ATTACHMENTS FOR COUNCIL MEETING

Herring Road Urban Activation Precinct

August 12, 2014

City of Ryde

Figure 1 - Bicycle Master Plan

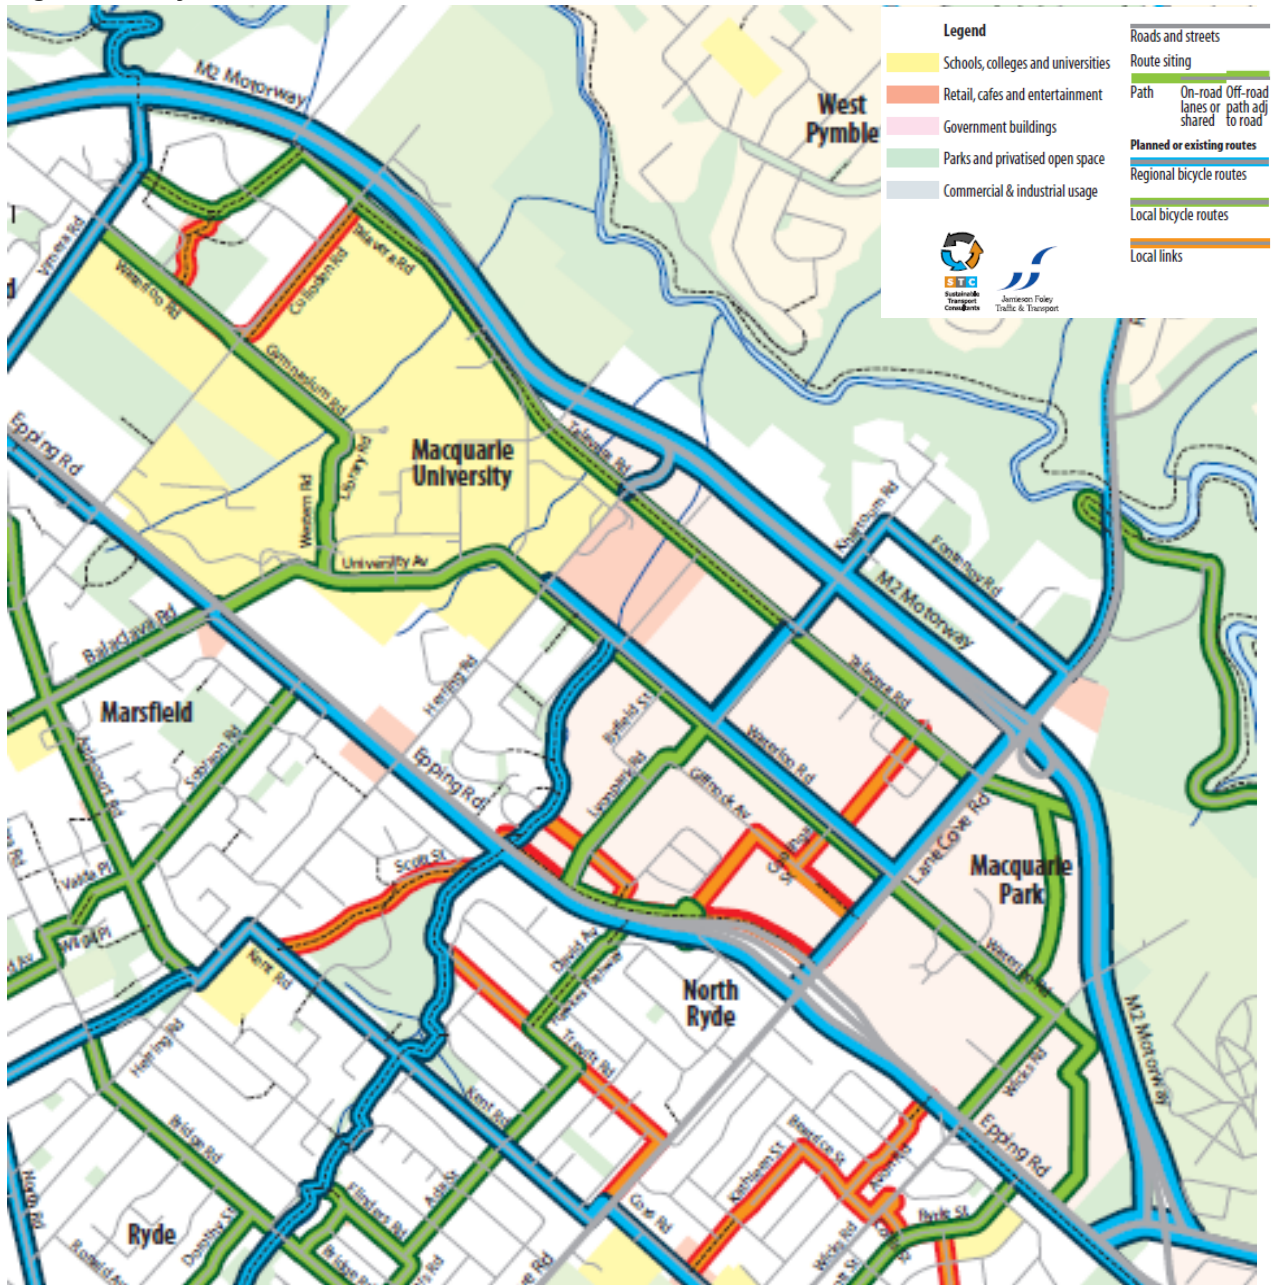
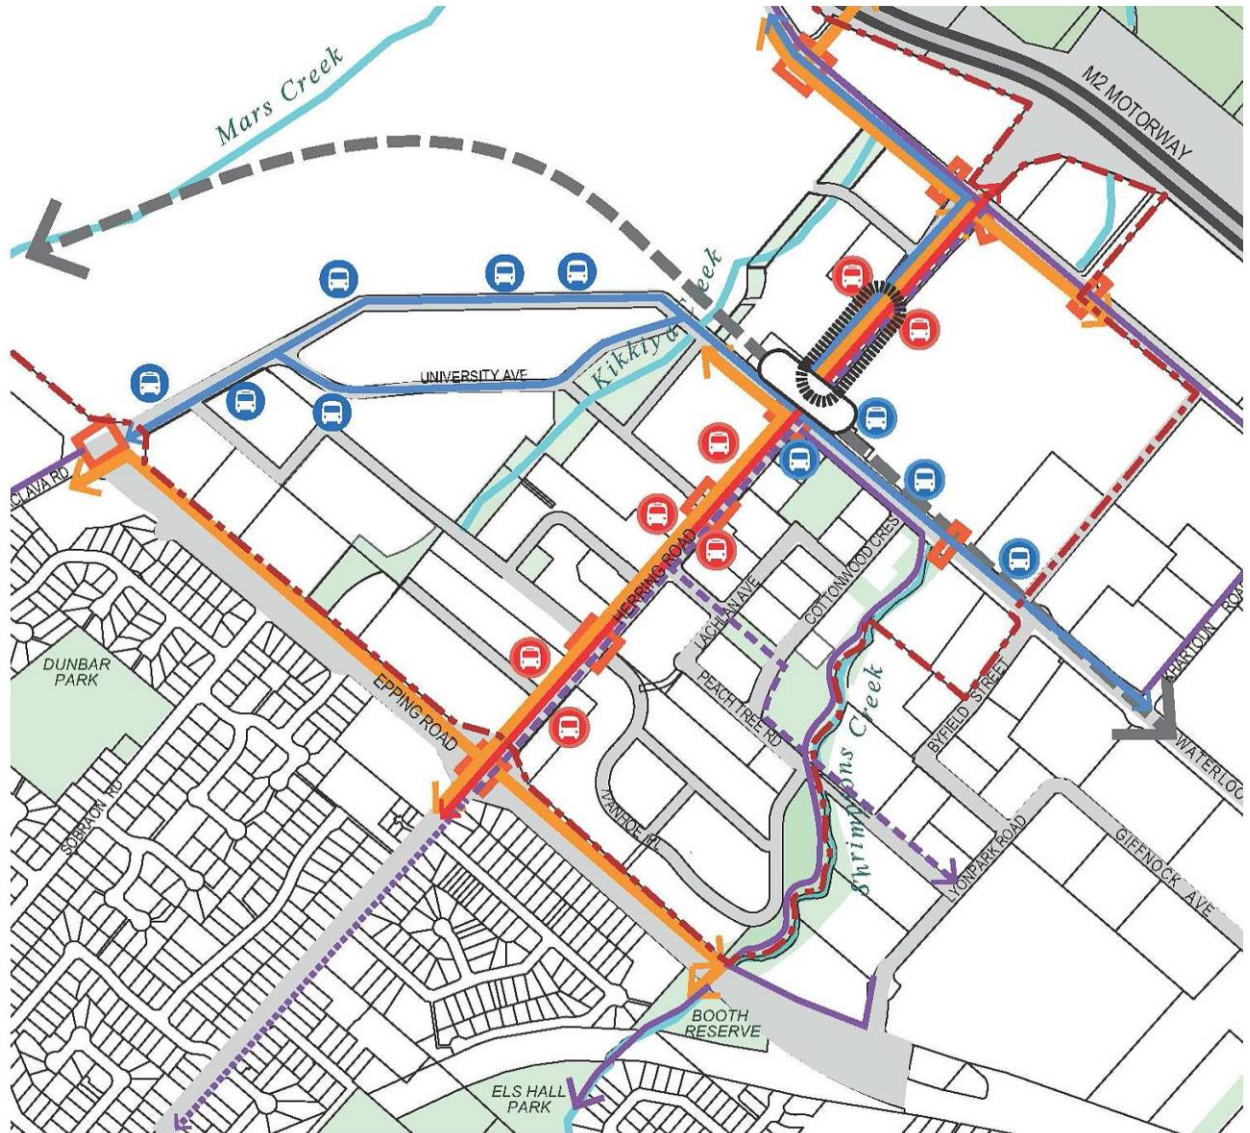
The UAP Planning Report does not appear to give any consideration to the *Ryde Bicycle Strategy and Master plan 2007*. Whilst existing paths are considered within the UAP Planning Report, this master plan identifies future intended links in around the area. An extract is provided below at Figure 1.

From the above Figure it can be seen that there are a range of different cycle routes surrounding the UAP area. The proposed Cycle network depicted in Figure 2 below fails to provide for new connections into the network. It does not connect into the proposed cycle routes along Waterloo Road, Epping Road (currently required as a condition on the Macquarie University Concept Plan), Balaclava Road, and other surrounding roads. These missing links could be imposed as part of the significant development uplift proposed by the UAP. It is also puzzling that the pedestrian networks detailed within the UAP as provided at Figure 2 do not align or reflect those shown within Figure 42 of the Planning Report, reproduced as Figure 3 below. In particular, the Department’s attention is drawn to the links along Kikkiya Creek and between Peach Tree Road and Ivanhoe Place.

Figure 8 - Building heights under the UAP

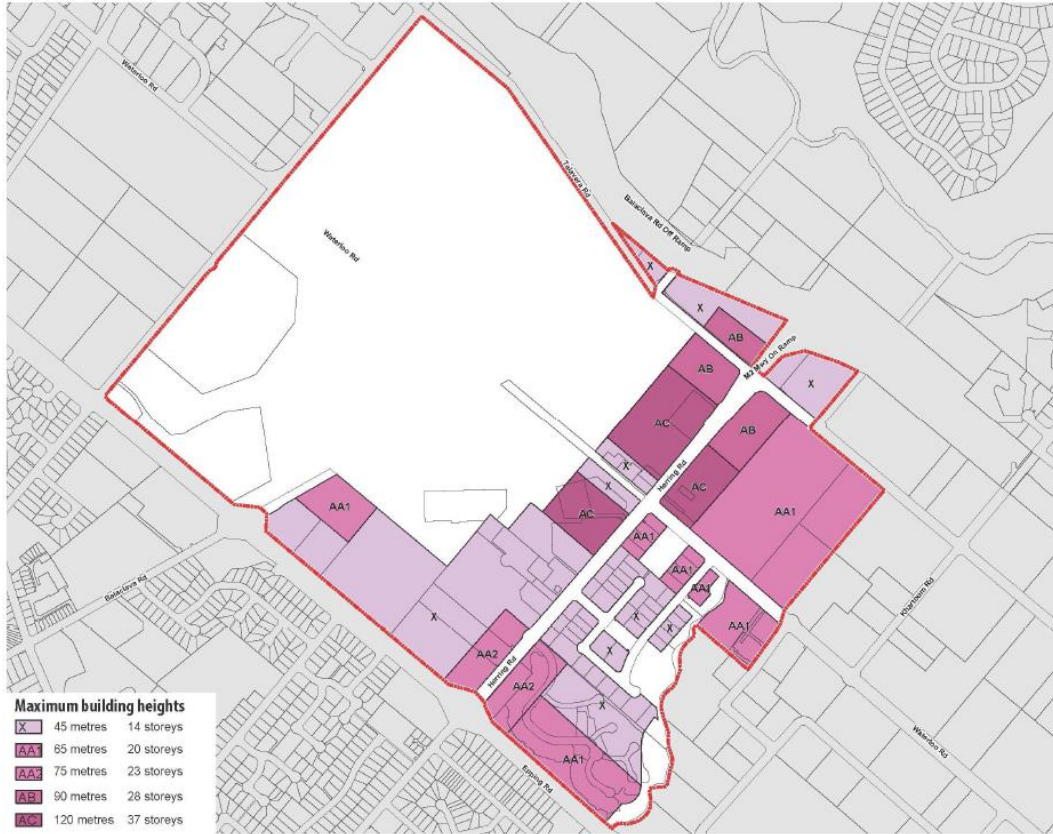
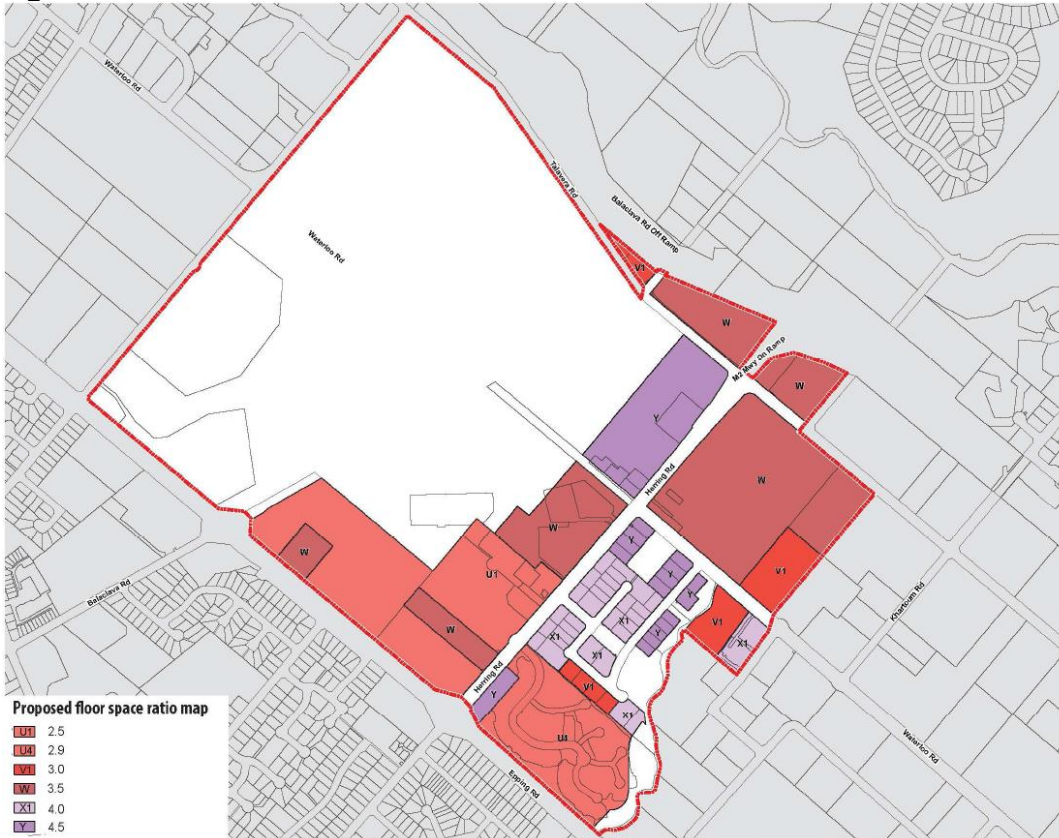
In light of the above, it is noted that there appears to be a disconnect in the heights and FSRs proposed for 157 Balaclava Road and 159-161 Epping Road. In particular, it is noted that it appears as though the FSR of 3.5:1 is not in the same location as the increased heights of 65m. This must be clarified.

Figure 12 - Macquarie Park Urban Form

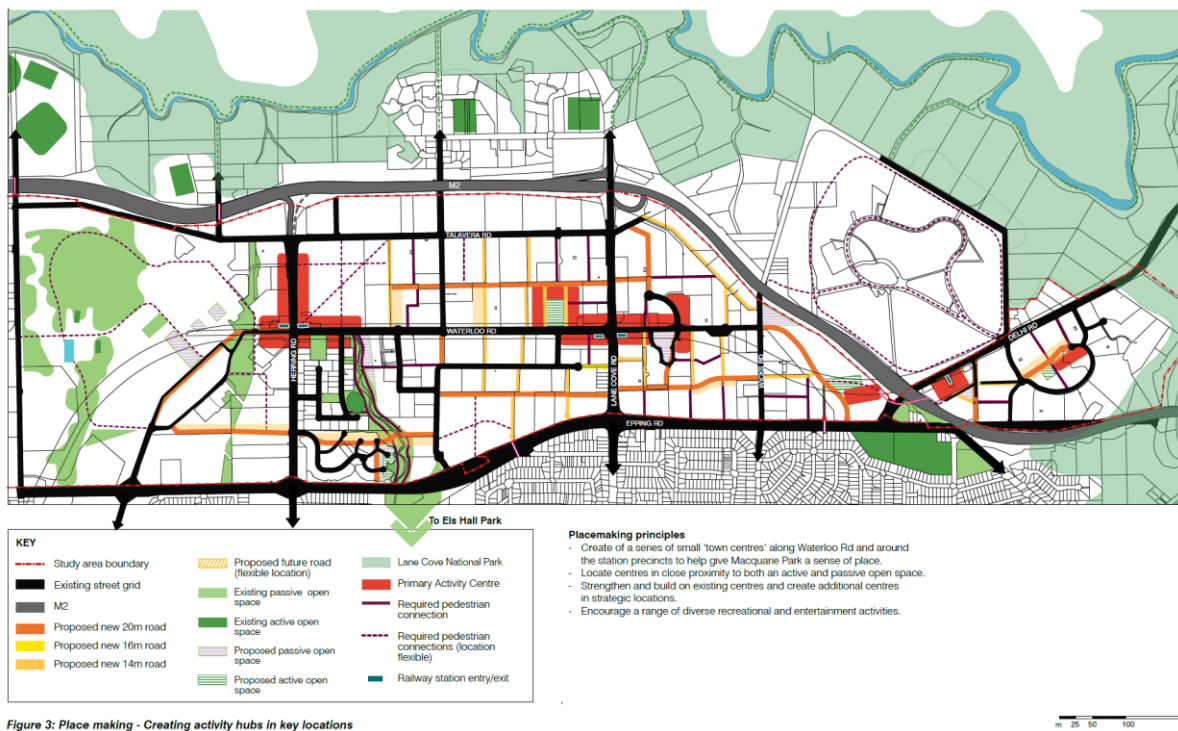
Zero side setbacks should be nominated for buildings fronting Herring Road in the section where it is envisaged that retail uses will occur. It is noted that a "street wall" building typology can only be achieved with zero side setbacks. Zero side setbacks also facilitate continuous all weather protection. What this means for the uses above ground level and nominal building depths has not been detailed within the submission. The stylised building envelope provided at Figure 52 of the UAP Planning Report appears to propose built to boundary podium style development that has significant depth. Presumably, this will not permit residential uses on the 6-8 storey street wall? It is noted that awnings are indicated on the detailed street section of Herring Road. Whether this is an appropriate built form for the entire length of Herring Road is questionable. This will be influenced by the active frontage location and whether it is feasible to have this for the entire length of Herring Road. Work undertaken as part of Amendment 1 is detailed at Figure 12 which details potential locations of active frontages.

However it must be recognised that it is unlikely that the entire length of Herring Road will be retail / commercial land uses. It is recommended that targeted areas for retail / commercial land uses be identified. This would then allow further resolution of the street setbacks to ensure that sufficient amenity is provided on the ground floor. As identified elsewhere in this submission, it is noted that some amendment / further resolution of the type of traffic, pedestrian environment and cycling infrastructure along Herring Road is required. This will then need to require a significant redesign of the treatment of Herring Road which may need for the widening of Herring Road to occur. This must be considered as part of any proposed setbacks.

Additionally, a zero setback on Waterloo Road may not be possible due to the Epping to Chatswood rail line which is located below Waterloo Road and constrains future development outside the railway stratum.

Figure 13 - Open Space Structure Plan

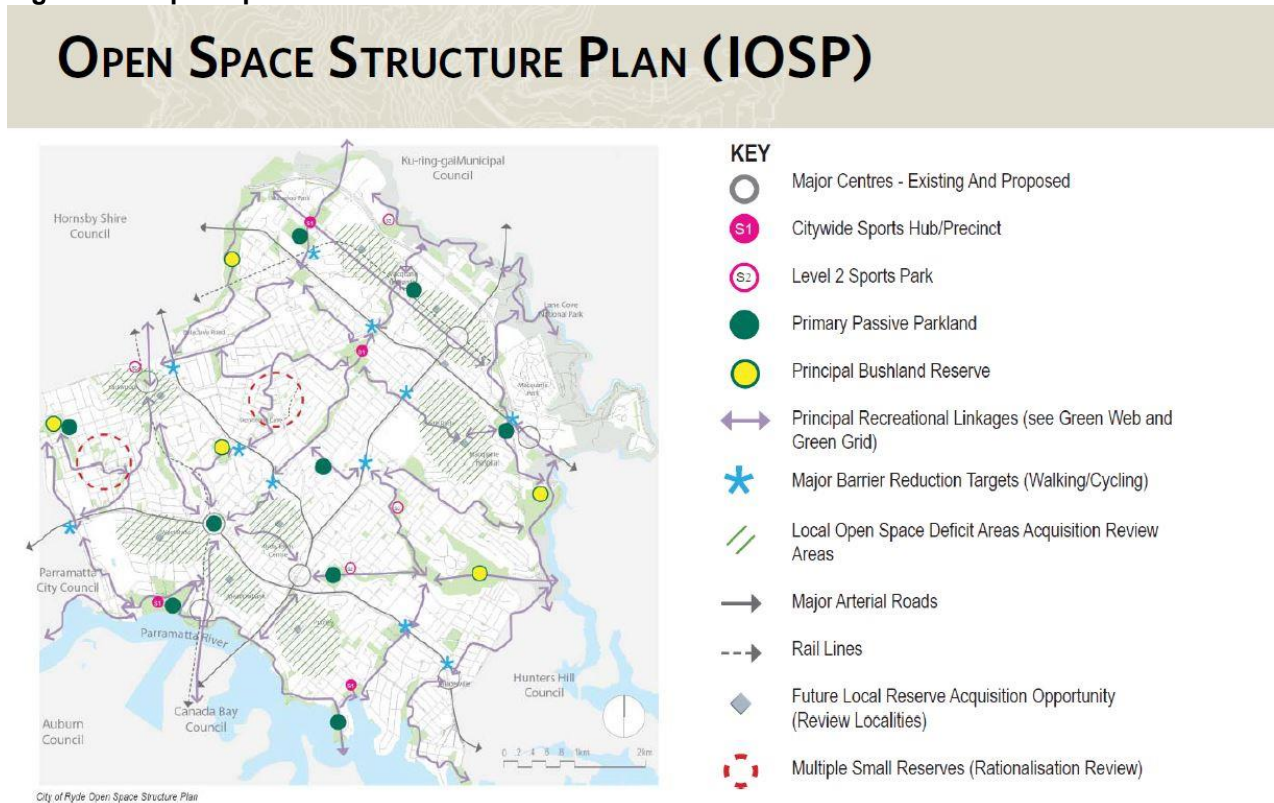
Extensive work undertaken by Council in its Integrated Open Space Plan 2012 (IOSP) analysed existing open space in the City of Ryde – its function and size. Based on this investigation, an open space deficiency in the Macquarie Park Corridor was identified as being local open space deficient as detailed in Figure 13.

This deficiency will be exacerbated by projected growth in residential and worker populations in Macquarie Park excluding the UAP. The population of Macquarie Park is forecast to increase by over 60% from around 6,600 people in 2014 to over 10,000 by 2031. This does not include the additional population afforded by the UAPs. In addition to the demand generated by the residential population, economic growth will double worker numbers by 2031 from 40,000 to over 80,000. In 2013 Council estimated that the overall open space in City of Ryde was around 3.22 hectares per 1,000 people. The Macquarie Park Corridor was significantly lower at 2.7 hectares/1000 people.

Figure 14 - Open Space Network under Amendment 1

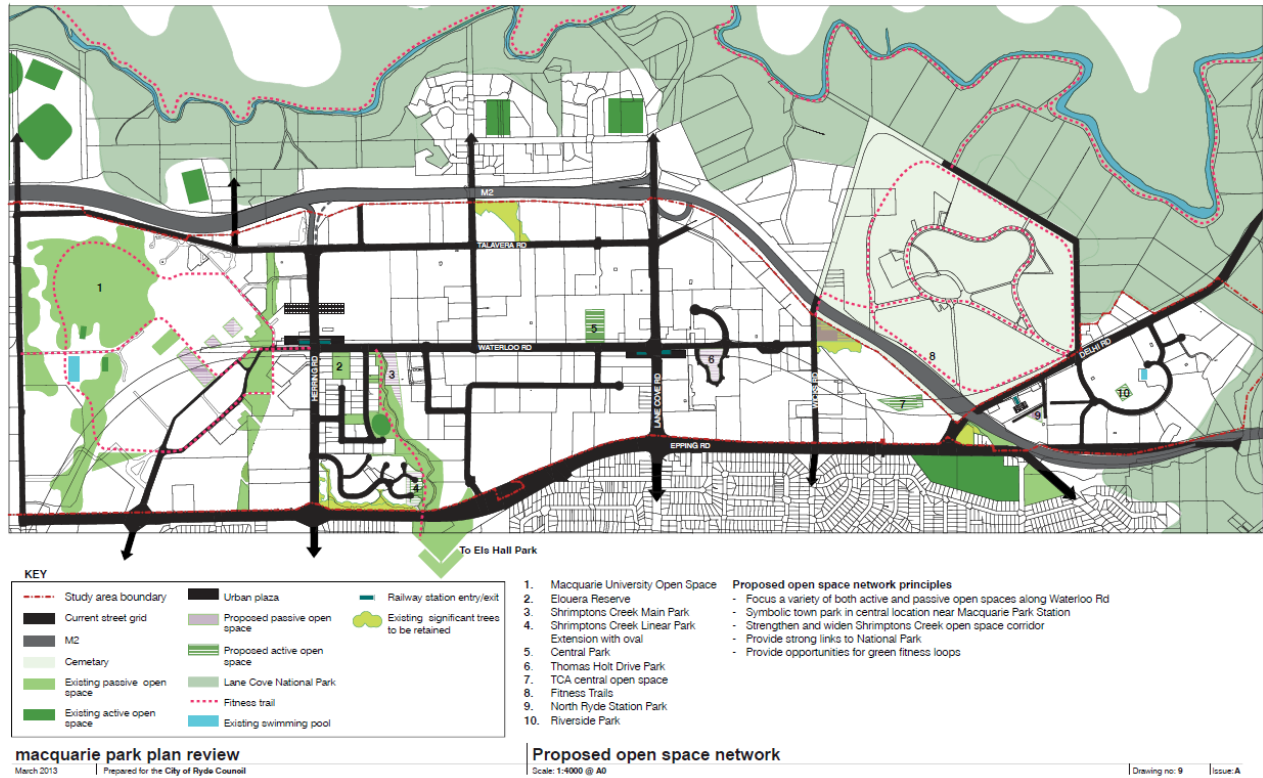
The work undertaken by Council as part of Amendment 1 identifies potential areas of increases to open space within and adjacent to the UAP area. These can be seen in Figure 14 below as Items 2, 3 and 4.

The UAP represents an opportunity to further capitalise on the work undertaken by Council as part of Amendment 1 and further expand and embellish the Shrimptons Creek Park network. This will deliver open space while enhancing the pedestrian/cycling networks through the precinct. The work undertaken as part of Amendment 1 did not envisage as significant an increase in residential population as that proposed under the UAP and as such, there clearly is a demand for the increasing of open space beyond that detailed in Figure 14.

Figure 4.1: UAP Street Network Compared to LEP 2013 Draft (Amendment 1) Street Network

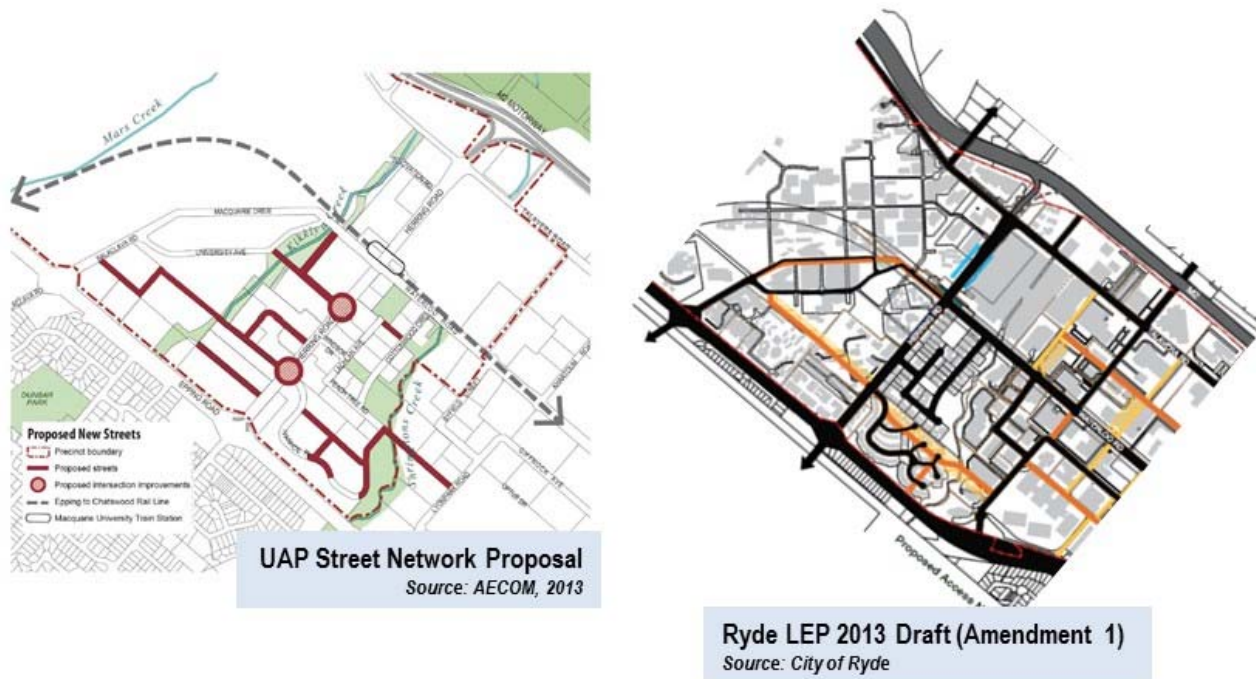
It is unclear why the UAP proposal is to make this road one-way eastbound only and there would be significant benefits of making this link two-way to reduce pressure on Waterloo Road for local trip making. Similarly, it is unclear why the link from Cottonwood Crescent to Lachlan Avenue needs to be one way. Rat running through this area would be minimal in the north-eastbound direction given the two right turns required to do this and the circuitous nature of the route.

Also, the extension of Ivanhoe Place with a new road along the creek to connect to Peach Tree Road was not envisaged in the LEP Amendment and there may be some alignment challenges with this link and its proximity to the creek.

The key difference between the LEP Amendment and the UAP street networks is that that LEP Amendment street network has a finer grained road system proposed for the area west of Herring Road and south of the Waterloo Road intersection. This fine grained network may still be achievable in this area as part of the development planning of specific sites.
